Access Compliance Report

Public Rights-of-Way

Intersection ID: 18346	Main Street: OLD_PINEVILLE_RD	Cross Street: MINUET_LN	Location: NW
ADA ID: 6C16919A5ED7	Ramp Type: ParaDiag	Initial Pass/Fail: Fail	Overall Compliance: No
			Severity Score: 13.75

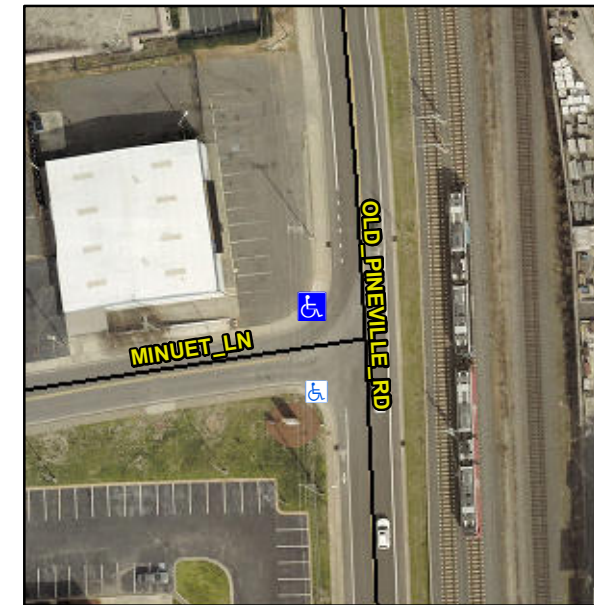
R304.3.2, R304.5.3

Compliance	Description	Data	Compliance	Description	Data
N/A	Ramp Length LT (in)	51.5	N/A	Ramp Length RT (in)	55.0
Yes	Ramp Width LT (in)	73.0	Yes	Ramp Width RT (in)	73.0
No	Ramp Slope LT (%)	8.4	Yes	Ramp Slope RT (%)	5.6
No	Ramp XSlope LT (%)	3.7	Yes	Ramp XSlope RT (%)	1.7
N/A	Landing Length (in)	N/A	N/A	DWS Provided?	N/A
N/A	Landing Width (in)	N/A	N/A	DWS Contrast?	N/A
N/A	Landing Slope (%)	N/A	N/A	DWS Length (in)	N/A
N/A	Landing X Slope (%)	N/A	N/A	DWS Full Width?	N/A
N/A	Landing Curb? (Y/N)	N/A	N/A	DWS Offset (in)	N/A
N/A	Shared Landing?	N/A			
N/A	Gutter Ponding?	N/A	N/A	Gutter Slope (%)	N/A
N/A	Gutter Lip Ht (in)	N/A	N/A	Gutter X Slope (%)	N/A
N/A	Painted X Walk1?	No	N/A	Painted X Walk2?	No
	X Walk 1 Direction	To S		X Walk 2 Direction	To E
N/A	X Walk 1 Width (in)	N/A	N/A	X Walk 2 Width (in)	N/A
	X Walk 1 Slope (%)	2.3		X Walk 2 Slope (%)	2.6
	X Walk 1 X Slope (%)	2.3		X Walk 2 X Slope (%)	1.5
N/A	Ramp inside XWalk1?	N/A	N/A	Ramp inside XWalk2?	N/A

Remove & Replace Curb Ramp With Two New Directional Ramps or Equivalent.
